MIL-R-39016/34E
AMENDMENT 2
29 March 1993
SUPERSEDING
AMENDMENT 1
29 October 1992

MILITARY SPECIFICATION SHEET

RELAYS, ELECTROMAGNETIC, DPDT, LOW LEVEL TO 1 0 AMPERE,
(0 100-INCH TERMINAL SPACING)

This amendment forms a part of MIL-R-39016/34E, dated 22 June 1992, and is approved for use by all Departments and Agencies of the Department of Defense

FIGURE 1 Outline and dimensions

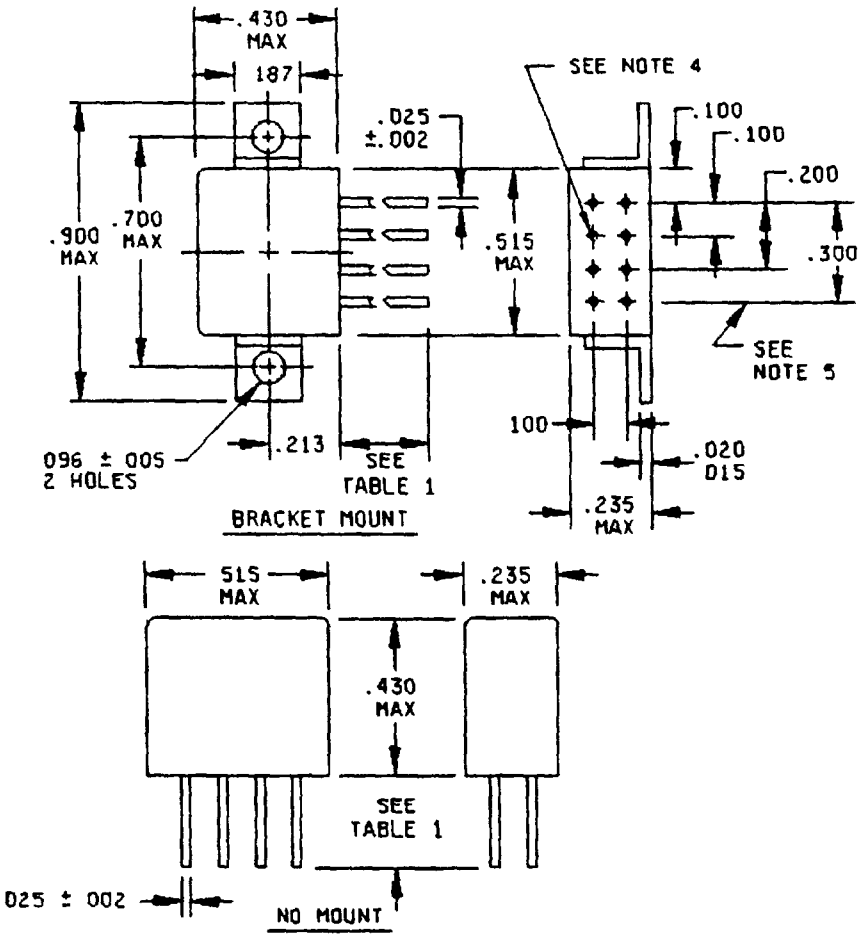
FIGURE 1, delete in its entirety and substitute

FIGURE 1, tab mount, delete " 505 MAX" and substitute " 515 MAX"
